**ITEM 6. DEVELOPMENT APPLICATION: 105-115 PORTMAN STREET
ZETLAND - SITE 12A****FILE NO: D/2015/294****DEVELOPMENT APPLICATION NO: D/2015/294****SUMMARY****Date of Submission:** 6 March 2015

Applicant: Urbis Town Planning Consultants**Architect:** SJB Architects**Developer:** BridgeHill Zetland Pty Ltd**Owner:** BridgeHill Zetland Pty Ltd**Cost of Works:** \$105,699,530**Proposal Summary:** Development application for the construction of a mixed use development comprising 3 buildings of a scale of 9 storeys, 11 storeys and 15 storeys above 2 levels of basement car parking. The proposal incorporates 330 apartments, retail tenancies along future Geddes Avenue, 313 car parking spaces, tree removal and landscaping.

The site is known as Development Site 12A (Site 12A) within the Green Square Town Centre development controls. A competitive design process was undertaken for the site.

Figure 19: GSTC DCP 3m secondary setback zone shown in outline identifying minor non-compliances

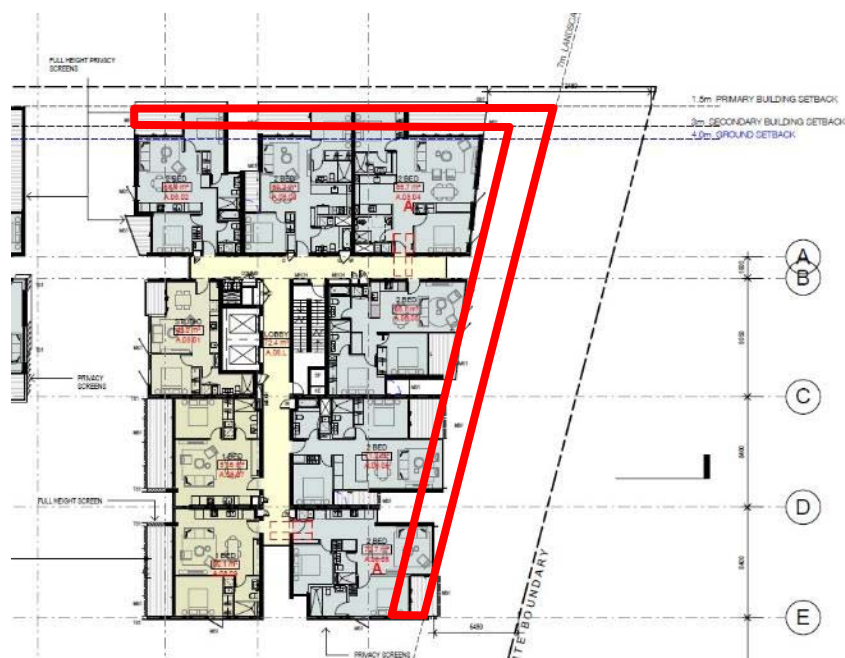
65. GSTC DCP requires the levels above the eighth storey along Geddes Avenue and Portman Street to have a minimum secondary setback of 3m to create a street wall. Building B has a compliant secondary setback along Geddes Avenue. However, Building A is inconsistent with the control because it has a tower form without secondary setbacks.

66. The proposed 8 storey street wall height variation is supported in relation to Building A on each frontage. The non-compliance relates to 16% of the site frontage along Portman Street and 28% of the Geddes Avenue frontage. The variation is supported for the following reasons:

Figure 20: Extract of floor plan showing Sonny Leonard Street ground floor and first floor setback non-compliance

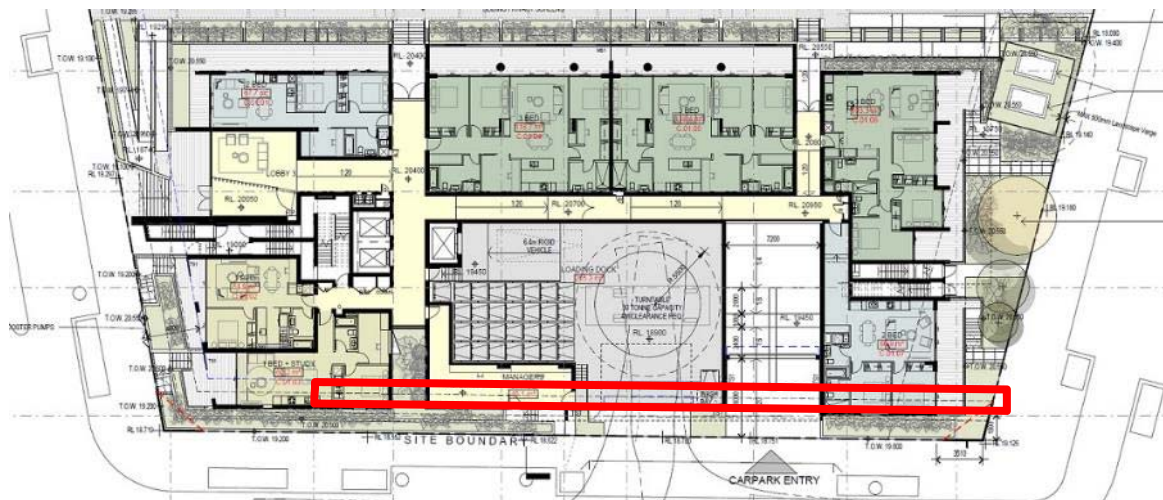
70. The proposed Sonny Leonard Street building setback is between 1.6m and 2m for the full height of the development. This complies with the 1.5m full height setback. However, it does not comply with the additional 4m setback control at ground and first floors.

71. The proposed non-compliance is not acceptable for the following reasons:
- the building would be out of alignment with the setback of the adjacent approved development to the west (see **Figures 21 and 22** below). The adjacent development provides ground and first floor setbacks between 4.0m and 4.9m and this building form should be carried through to Site 12A in accordance with the planning controls. There is not sufficient grounds to vary the control; and
 - insufficient landscape relief is provided for the residential uses along the street and landscape screening is not sufficient for non-residential uses comprising a manager's office and loading/waste area.

72. Council Officers have modelled the impacts of enforcing the 4m ground and first floor setback on the development. The following changes would arise and are required to be documented to the satisfaction of the Director City Planning, Development and Transport within the recommended conditions:
- (a) two apartments, one per floor, would have to be deleted at the south-western corner;

Figure 23: Portman Street 7m setback non-compliance

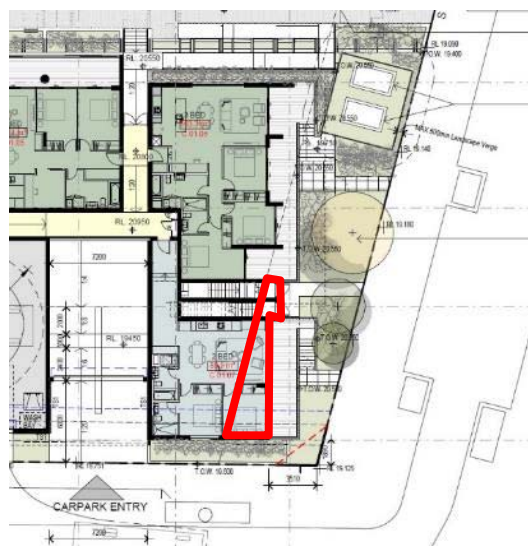
76. The proposal is non-compliant in relation to a portion of Building C. The southern-most 40% of the building encroaches into the setback by between 0.8m and 3m.

77. The proposed non-compliance in relation to Building C is considered acceptable for the following reasons:
- (a) Site 12B to the south has a 4m setback at ground and first floor, then a 1.5m full height setback. Accordingly the Portman Street setback for Building C provides a transition to Site 12B, gradually from 7m to 4m. In addition, the development at Site 12B will be relatively closer to the street above the first floor. As such the reduced setback for Building C will not be as readily discernible;

84. The proposal includes two pad mount substations along Portman Street within the 7m landscaped setback zone. These are shown in the top right hand corner of Figure 23 above.

Figure 24: Extract of proposed Sonny Leonard Street floor plan showing active frontage and inactive frontage.

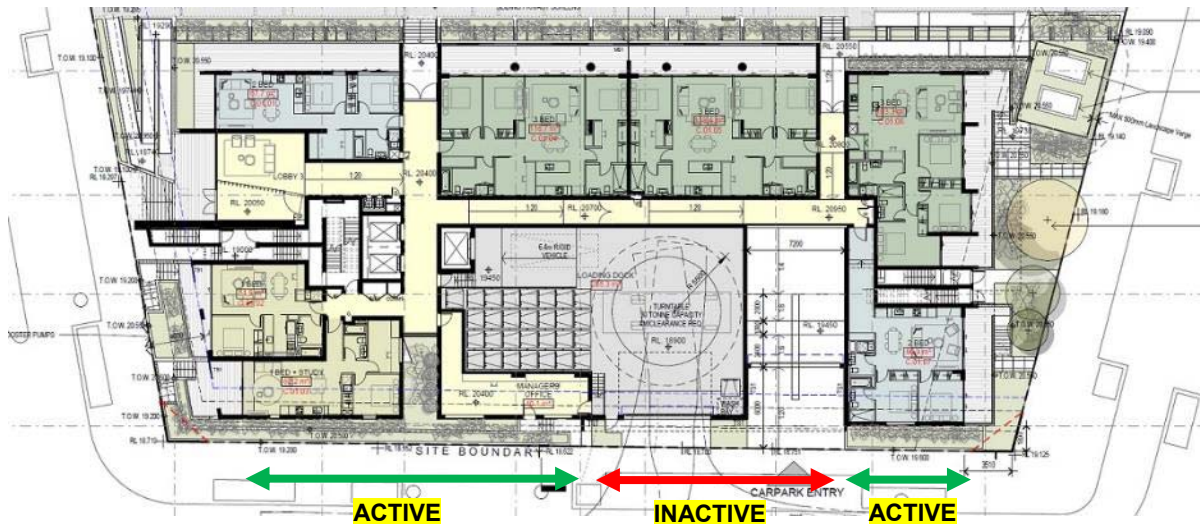
82. Opportunities to relocate vehicle access, combine the vehicle cross-overs and increase the active frontage of the development have been explored. As such, the active frontage has been maximised as much as possible.

83. Commentary above confirms the intention of Council Officers to enforce a 4m landscape setback control at ground and first floor levels. This will provide additional landscaped screening to the inactive uses.
